CALLAWAY PLANT, UNIT 1

AMENDMENT TO FACILITY OPERATING LICENSE

Amendment No. 36
License No. NPF-30

SAFETY EVALUATION BY THE OFFICE OF NUCLEAR REACTOR REGULATION
RELATED TO AMENDMENT NO. 36 TO FACILITY OPERATING LICENSE NO. NPF-30

Figure 3.4-2

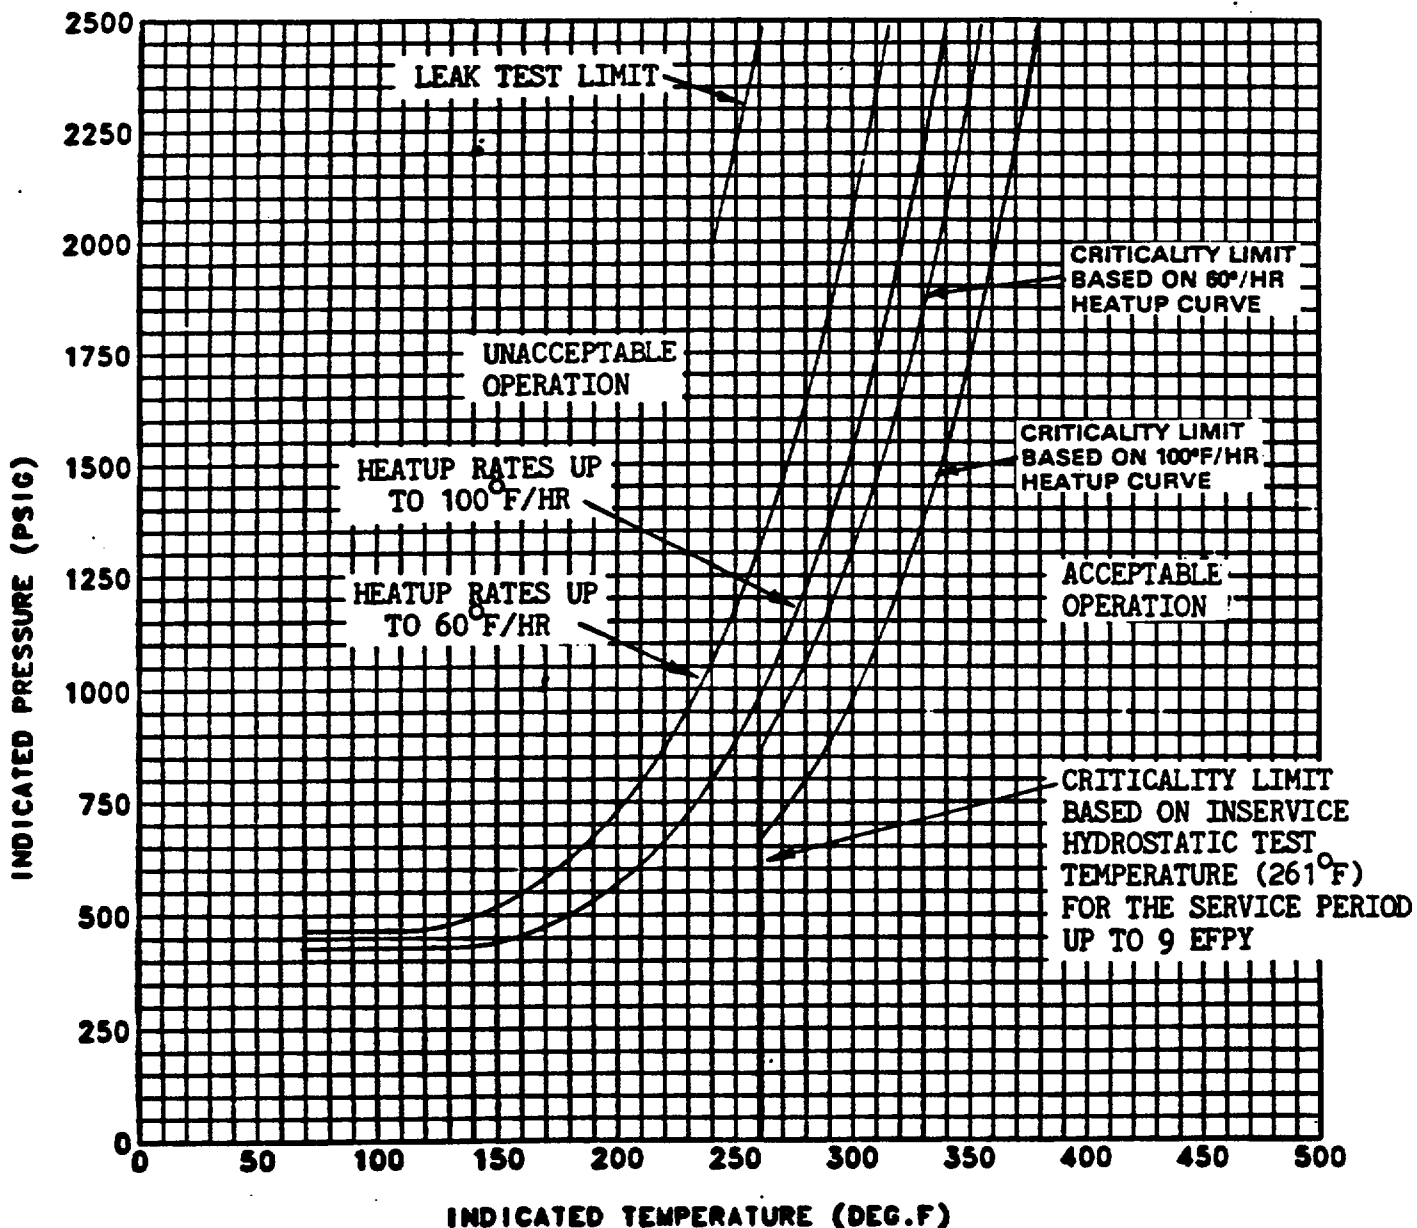
The amendment revises the plant heatup and cooldown curves, revises the maximum allowable power operated relief valve (PORV) setpoint curve, and revises the reactor vessel surveillance capsule removal schedule.

By letter dated July 31, 1987, as supplemented by letter dated February 19, 1988, the Union Electric Company requested revision of the pressure-temperature limits in Callaway Plant Technical Specifications Section 3/4.4.9. The proposed limits will incorporate the updated pressure vs. temperature curves through 9 effective full power years (EFPY) to account for irradiation effects on the reactor vessel material. The proposed limits were based on the Westinghouse analysis (WCAP-11374, Rev. 1) of irradiation data taken from surveillance specimen Capsule U. The limits provide maximum permissible pressure at temperature for three reactor operations--system hydrostratic and leakage test, heatup or cooldown, and core critical condition. The pressure-temperature limits have to satisfy the requirements in Appendix G of 10 CFR Part 50. The licensee also requested revision of the maximum allowed power-operated relief valve (PORV) curve for the cold over-pressure mitigation system, and a revision to the surveillance capsule withdrawal schedule based on the neutron fluence data taken from Capsule U.

The staff has used the method of calculating pressure-temperature limits in USNRC Standard Review Plan 5.3.2, NUREG-0800, to evaluate the proposed pressure-temperature limits. The amount of neutron irradiation damage was calculated based on Regulatory Guide 1.99, Rev. 2. The staff concludes that the proposed pressure-temperature limits meet the requirements of 10 CFR Part 50, Appendix G for 9 EFPY and may be incorporated into the Callaway Plant's Technical Specification. Also, the revised surveillance capsule withdrawal schedule satisfies the requirements of 10 CFR Part 50, Appendix H, and is acceptable.

FIGURE 3.4-4

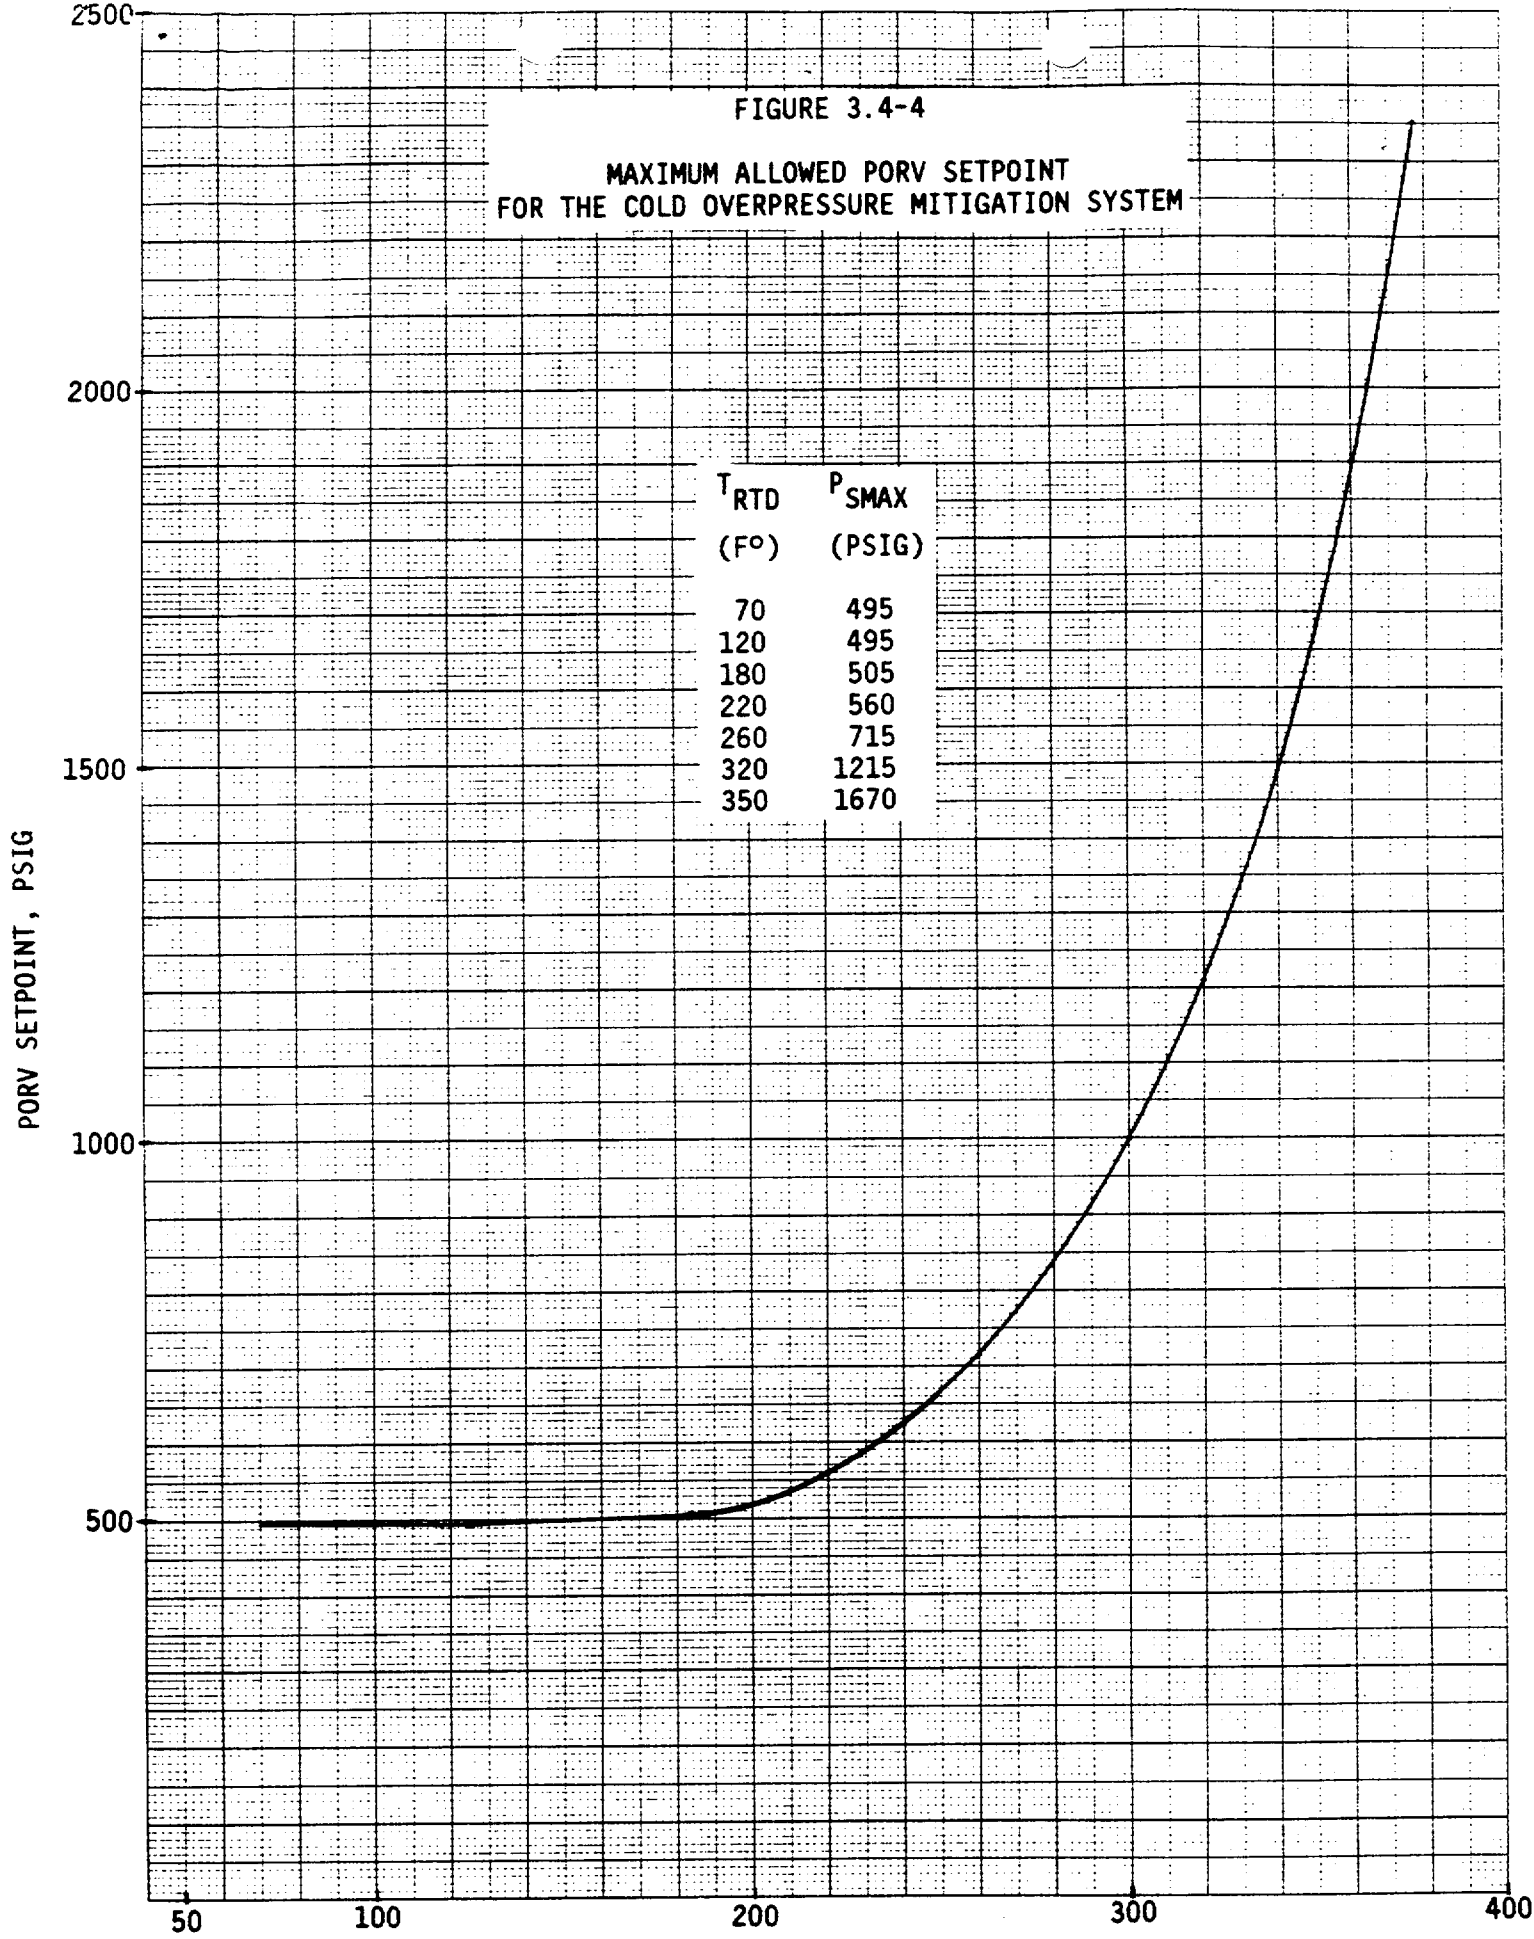
At the staff's request, the licensee provided the analyses, including the limiting mass and heat addition transients analyzed, the initial conditions, major assumptions and the results of the analyses, to support the maximum allowable PORV setpoints in the revised Figure 3.4-4.

The limiting mass addition transient involves the operation of a single charge pump at the maximum flow with inadvertent isolation of letdown flow and residual heat removal system (RHRS) relief valves. The limiting heat addition transient is an inadvertent RCS coolant pump startup in one loop with a temperature asymmetry in the RCS, whereby the steam generator is at a temperature 50°F higher than the rest of the RCS. The initial conditions and major assumptions include the pressurizer being water solid to maximize the pressure surge, the failure of one PORV, and the time delay in the PORV operation. As indicated in the licensee's response dated February 19, 1988, these transients and assumptions are identical to those used in the previous analyses in the Callaway FSAR Section 5.2.2.10 except for the use of the revised Figure 3.4-4 for the PORV setpoints.

The results of analyses indicate that the peak RCS pressures for the transients analyzed fall below the nominal Appendix G pressure limits. The staff, therefore, concludes that the revised Figure 3.4-4 is also acceptable.
